Petition No. 1606 – Endurant Energy petition for a declaratory ruling, pursuant to Connecticut General Statutes §4-176 and §16-50k, for the proposed construction, maintenance and operation of a 4.9-megawatt AC battery energy storage facility located at 65 and 105 Vine Street, Middletown, Connecticut, and associated electrical interconnection

Enclosed for filing with the Connecticut Siting Council ("Council") are Endurant Energy's responses to the Council's February 26, 2024 interrogatories.

Figure 4
Parcel and Site Boundaries

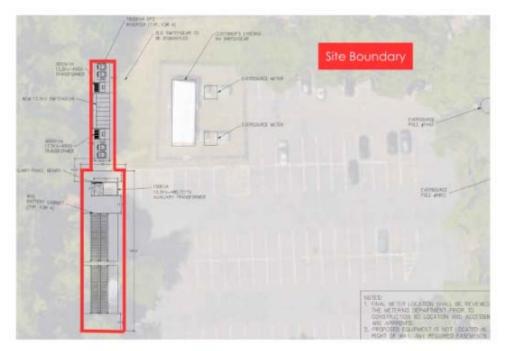
Q-CSC 3: Submit a map clearly depicting the boundaries of the battery energy storage facility (BESF) site and the boundaries of the host parcel(s). Under Regulations of Connecticut State Agencies (RCSA) §16-50j-2a(29), "Site" means a contiguous parcel of property with specified boundaries, including, but not limited to, the leased area, right-of-way, access and easements on which a facility and associated equipment is located, shall be located or is proposed to be located.

A-CSC 3: The Site is defined as the area of the host parcel that is to be leased by Endurant and is identified by the BESF perimeter fencing. No rights-of-way, access or easements are associated with the proposed Site. The final dimensions may vary slightly from what is shown depending on utility requirements. Please see the image below.

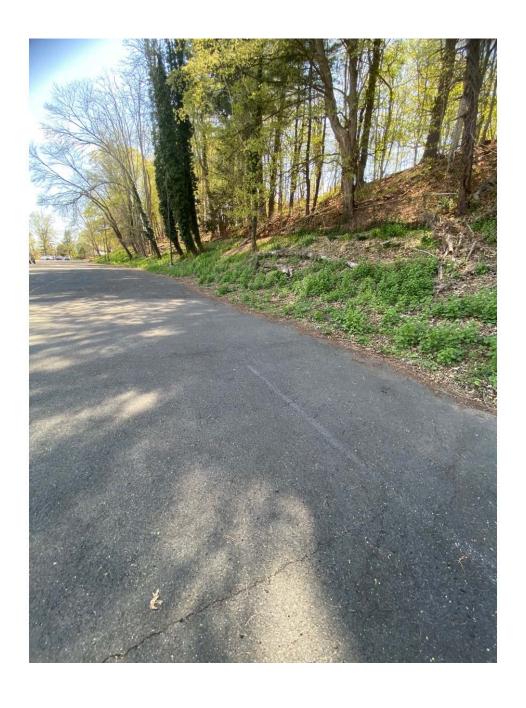
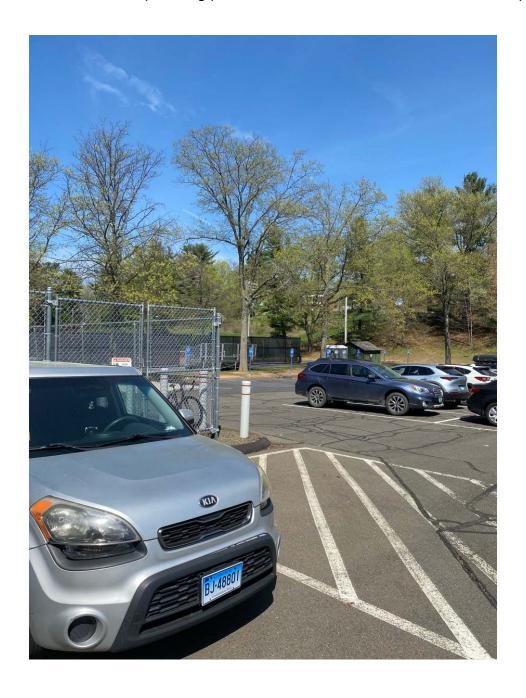
Q-CSC 40: Submit photographic site documentation with notations linked to the site plans or a detailed aerial image that identify locations of site-specific and representative site features. The submission should include photographs of the site from public road(s) or publicly accessible area(s) as well as Site-specific locations depicting site features including, but not necessarily limited to, the following locations as applicable:

A photolog graphic must accompany the submission, using a site plan or a detailed aerial image, depicting each numbered photograph for reference. For each photo, indicate the photo location number and viewpoint direction, and clearly identify the locations of site-specific and representative site features show (e.g., physical staking/flagging or other means of marking the subject area). The submission shall be delivered electronically in a legible portable document format (PDF) with a maximum file size of <20MB. If necessary, multiple files may be submitted and clearly marked in terms of sequence.

A-CSC 40: The attached photolog provides additional views of the area of the project.
